IS F

OUTLINE OF NEW FEATURES

The following changes have been made for the new IS F.

13V0NF12C		13V0NF13C	
Equipment		Option

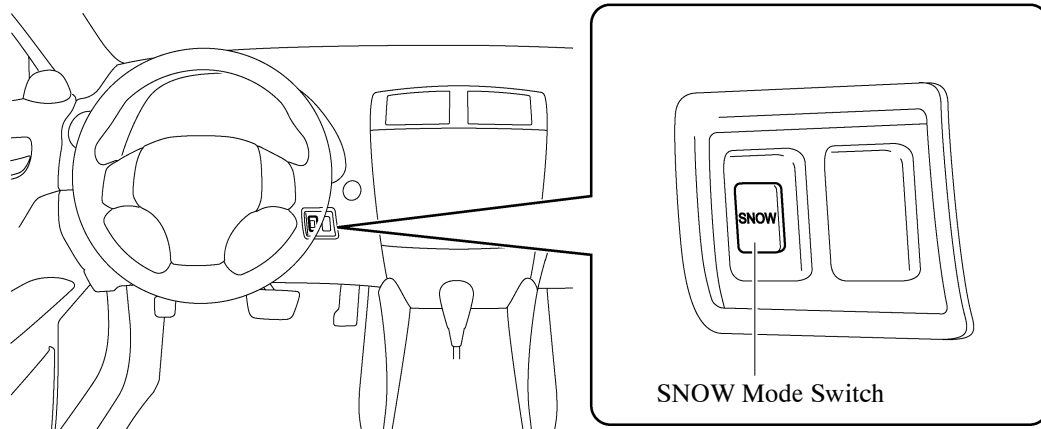
A new wheel design has been added.

Tire Size	Front		225/40 R19		
	Rear		255/35 R19		
Wheel	Size	Front	19 × 8J		
		Rear	19 × 9J		
	Material		Aluminum		
	Color (Color No.)		Dark Silver Metallic (11GY39)	Silver (11GY38)/Buffed Finish	
P.C.D.*	mm (in.)		114.3 (4.5)		
Inset	mm (in.)	Front	45 (1.8)		
		Rear	55 (2.2)		
Wheel Design		Left Side:		Right Side:

18Y01N02C

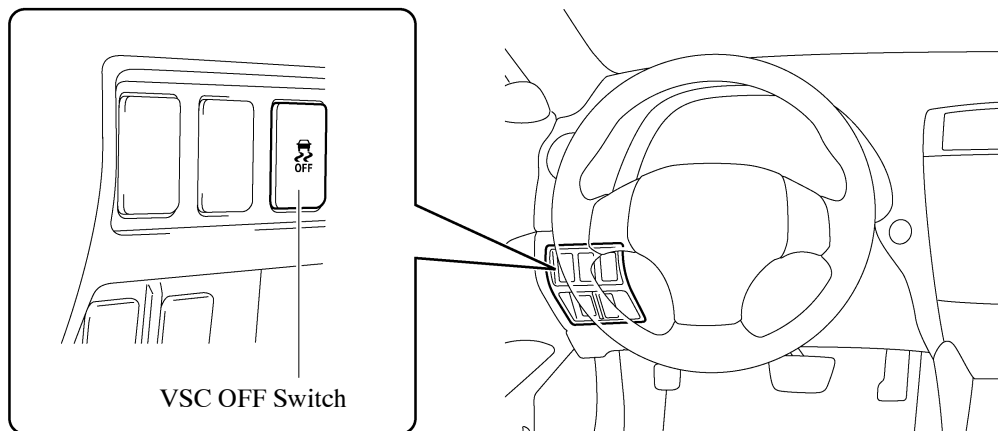
The location of the SNOW mode switch has been changed.

18Y0IN03C

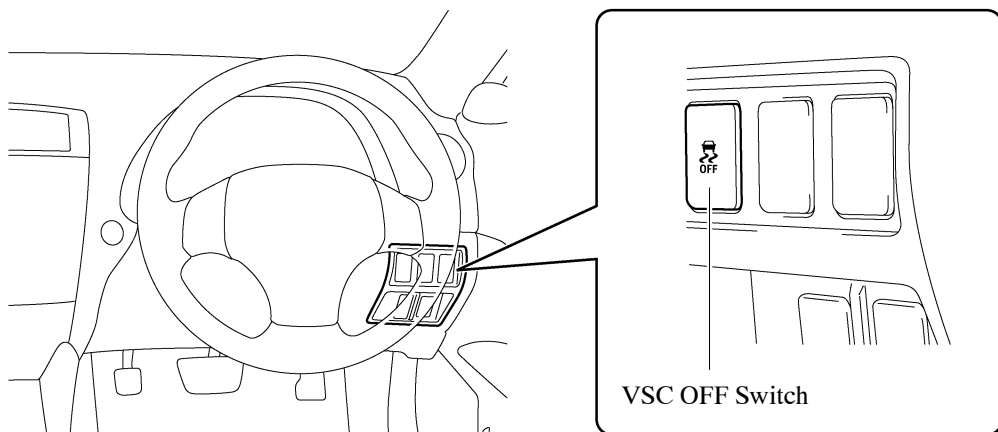
The location of the VSC OFF switch has been changed.
